North Eastern Regional Power Committee

Sub: Minutes of 68th Protection Coordination Sub-Committee (PCC) Meeting

68th Protection Coordination Sub-Committee Meeting

Date: 13/06/2024 (Thursday)

B.9 Grid Disturbance in Monarchak and Rabindranagar S/S of Tripura on 02-May-24:

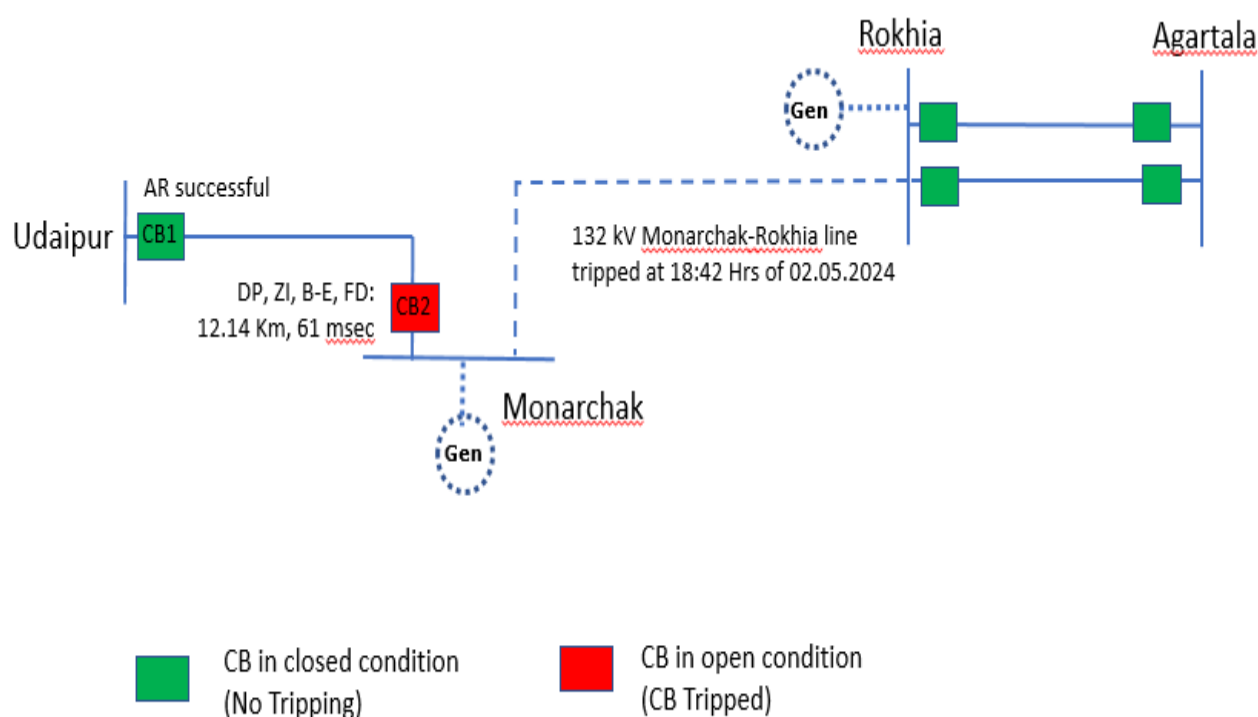
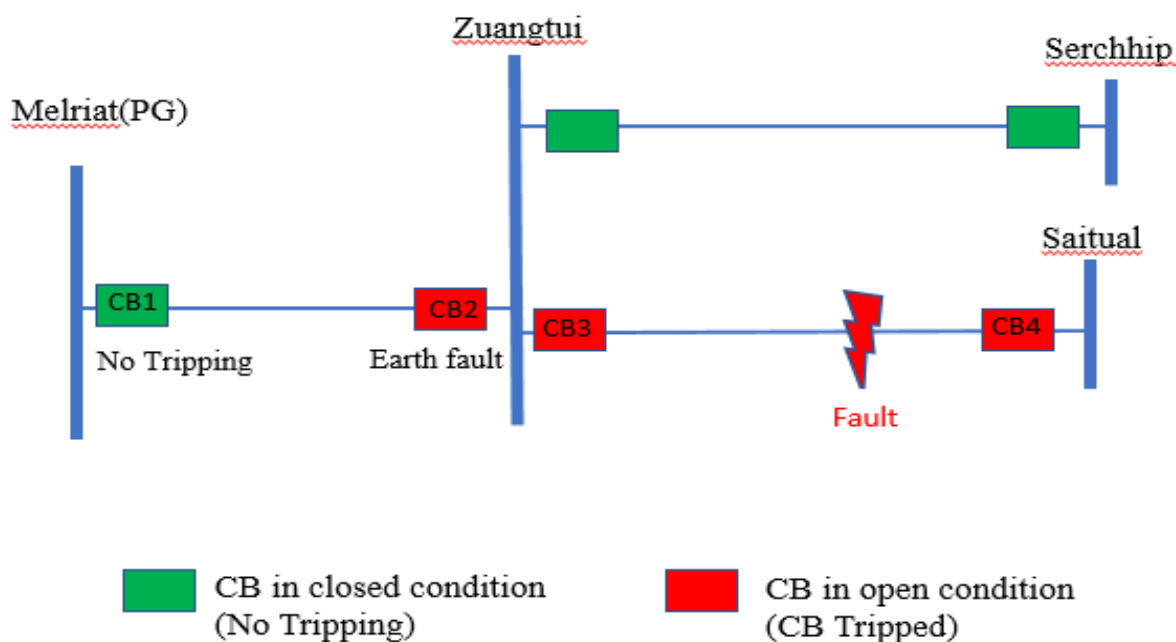
As per DR analysis of 132 kV Monarchak-Udaipur line, B-E fault (Ib-2.4 kA, In-2.6 kA) initiated at 18:32:20.233 Hrs and cleared within 61 msec on operation ZI from Monarchak end. Auto recloser was successful from Udaipur end.

Following observations:

- i) Huge DR time drift of 10 min at Monarchak and 8 min at Udaipur. Needs to be rectified by NEEPCO and TPTL.
- ii) DR time duration is insufficient at Udaipur. It should be extended to 3 seconds, with a pre-fault time of 500 milliseconds and a post-fault time of 2.5 seconds.
- iii) Flash Report and Detailed report not submitted by NEEPCO & TSECL which is violation of IEGC Section 37.2 (b) & (e).

1. TSECL updated that the tripping of Monarchak-Udaipur line occurred due to transient fault and AR at Monarchak end had been kept off as there was no PLCC on the line.
2. Forum requested NEEPCO and Tripura to address the issue of DR time drift at the earliest.

B.12 Frequent Grid disturbances in Myntdu Leshka HEP of Meghalaya Power System:

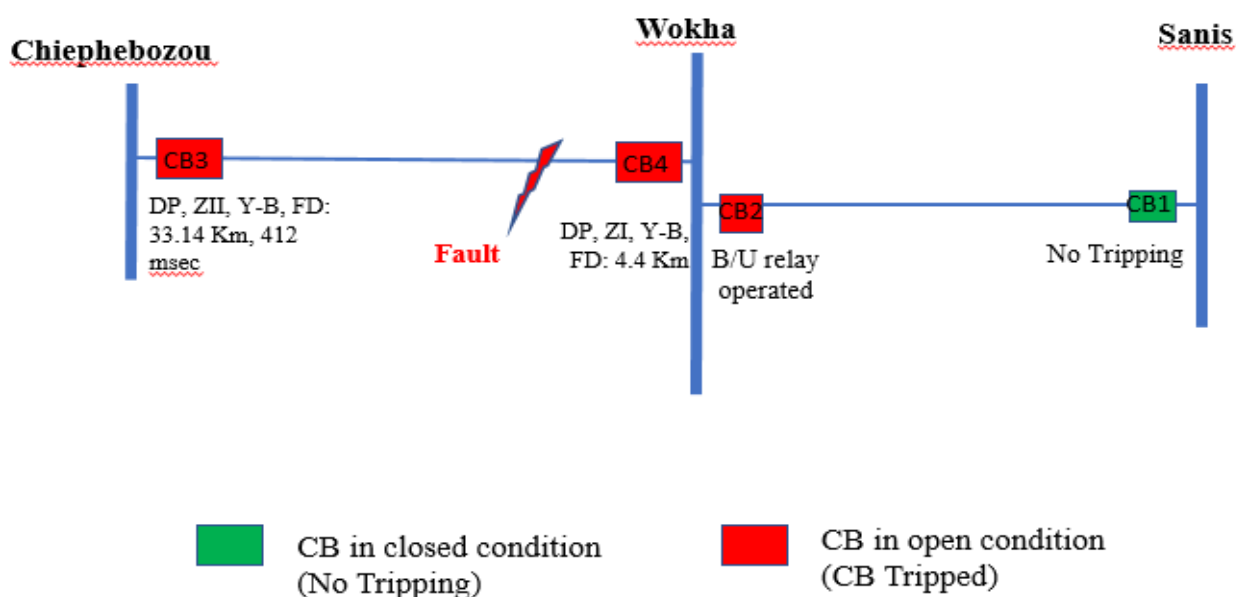
Following observations needs to be addressed:

1. There was no Auto reclose attempt observed. The auto-reclose (A/R) scheme should be inspected and activated to ensure the safe evacuation of Leshka generation by reclosing the line in case of single phase fault.
2. ZII time delay need to be reviewed as per NERPC protection philosophy.
3. DR channels needs to be standardized both ends:

- DR time duration appears to be insufficient at Leshka. It should be extended to 3 seconds, with a pre-fault time of 500 milliseconds and a post-fault time of 2.5 seconds.
 - DR time not synchronised, exhibiting time drift issue at Leshka & Khliehriat.
 - CB status is currently not allocated in the DR digital channel. It's essential for MePTCL and MePGCL to include CB ON/OFF status in DR channels at both ends for fruitful analysis of events.
4. MePGCL is requested to ensure that patrolling related activities are undertaken as per CEA (Grid Standard) Regulation, 2010 on regular basis and measures may be identified and implemented at the earliest so as minimize tripping of these lines.

1. Providing line differential protection on the link feeder
2. Installation of TLSA on the line
3. Single Phase AR on the line
4. DR standardization issue at Leshka & Khliehriat to be rectified. MePGCL agreed to resolve the issues by July'24.

MePGCL informed that a meeting will be held with State protection Committee regarding implementation of Auto recloser in 132 kV Leshka-Khliehriat D/C lines.

B.13 Grid Disturbance in Wokha area of Nagaland on 24-May-24:

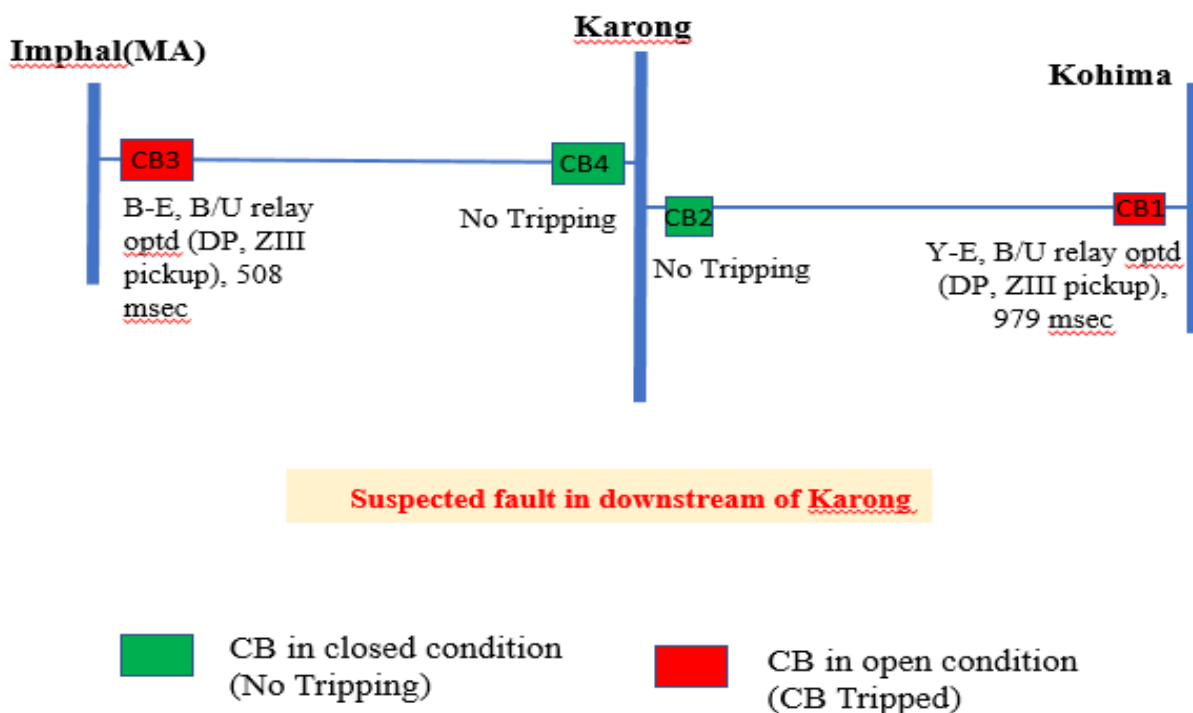
Following observations:

- i) Tripping of 132 kV Wokha-Sanis line from Wokha end on operation of backup protection for fault in 132 kV Wokha-Chiephebozou line (reverse fault) is unwanted.
- ii) DR time at Wokha end for 132 kV Wokha-Chiephebozou line and 132 kV Wokha-Sanis line is different from the event time.
- iii) DR of backup relay at Wokha end for 132 kV Wokha-Sanis line not submitted by DoP Nagaland.

DoP Nagaland may update the root cause and remedial measures taken.

DoP Nagaland informed that B/U relay at Wokha for 132 kV Sanis-Wokha line was disabled on 28.05.2024. However, even after disabling of the B/U relay, the relay is issuing trip command.

Forum asked DoP Nagaland to test the backup AVANA relay and switch the relay OFF till the issue gets resolved.

B.15 Grid Disturbance in Lumshnong area of Meghalaya on 30-05-2024:

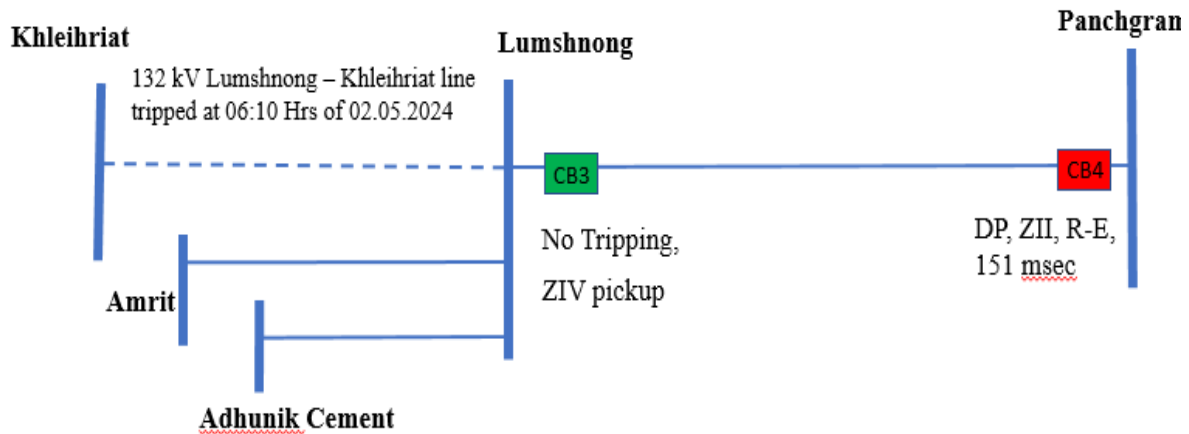
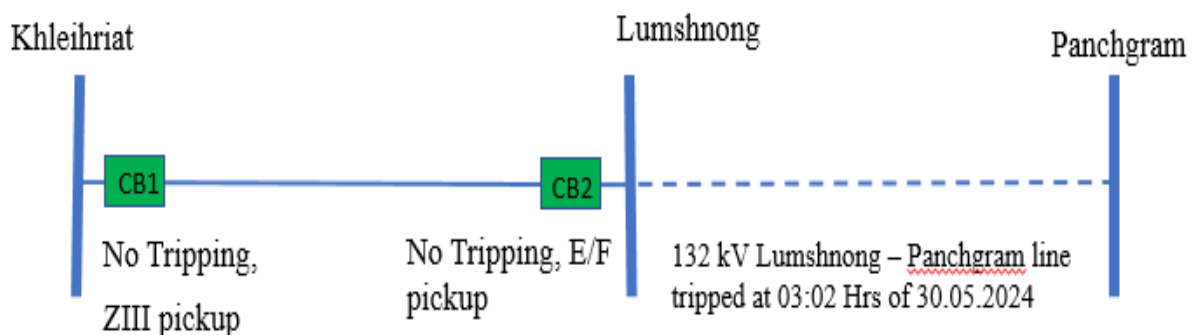
As per DR analysis, R-E fault (Ir-1.8 kA, In-1.4 kA) initiated at 07:00:11.821 Hrs in 132 kV Lumshnong-Panchgram line cleared within 151 msec on operation of DP, ZII from Panchgram end only. ZIV start at Lumshnong end which inferred that fault is in reverse direction.

It is unclear as to which protection system operated and cleared the fault. MePTCL may update.

- i) Share the root cause and remedial measures taken.
- ii) Protection setting coordination for 132 kV Amrit & 132 kV Adhunik Cement needs to be done by MePTCL.

1. MePTCL informed that fault was in 132 kV Amrit line.
2. Forum suggested AEGCL to increase ZII time delay at Panchgram to 250 msec for 132 kV Panchgram-Lumshnong line in coordination with PGCIL for 132 kV Badarpur-Panchgram Line.
3. Forum suggested MePTCL to enable High Set for B/U protection of 132 kV Amrit & 132 kV Adhunik Cement.

1. MePTCL informed at 06:39 Hrs, R-Y-B in 132 kV Lumshnong-Panchgram line cleared from Lumshnong in ZI. Again, Y-E fault reappeared and LBB operated at Lumshnong. (fault cleared 471 msec)
2. MePTCL informed arching must have occurred in the Y-phase interrupter pole. CB Y-pole will be replaced shortly within June'24.
3. Forum asked MePTCL to keep LBB time delay setting to 200 msec as per NERPC protection philosophy.

B.16 Bus Bar operation at Mawngap SS of Meghalaya on 29-05-2024:

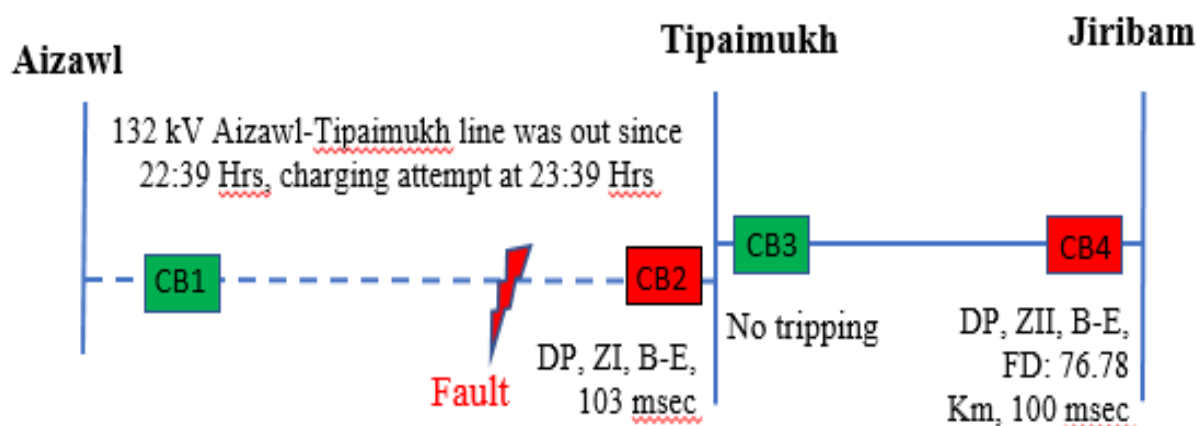
MePTCL is requested to intimate the reason of mal operation of Bus bar protection at Mawngap and remedial measures taken.

MePTCL stated that mal-operation of Bus Bar issue had to be resolved by NERPSIP. MS, NERPC stated that a communication will be done with to NERPSIP regarding the matter.
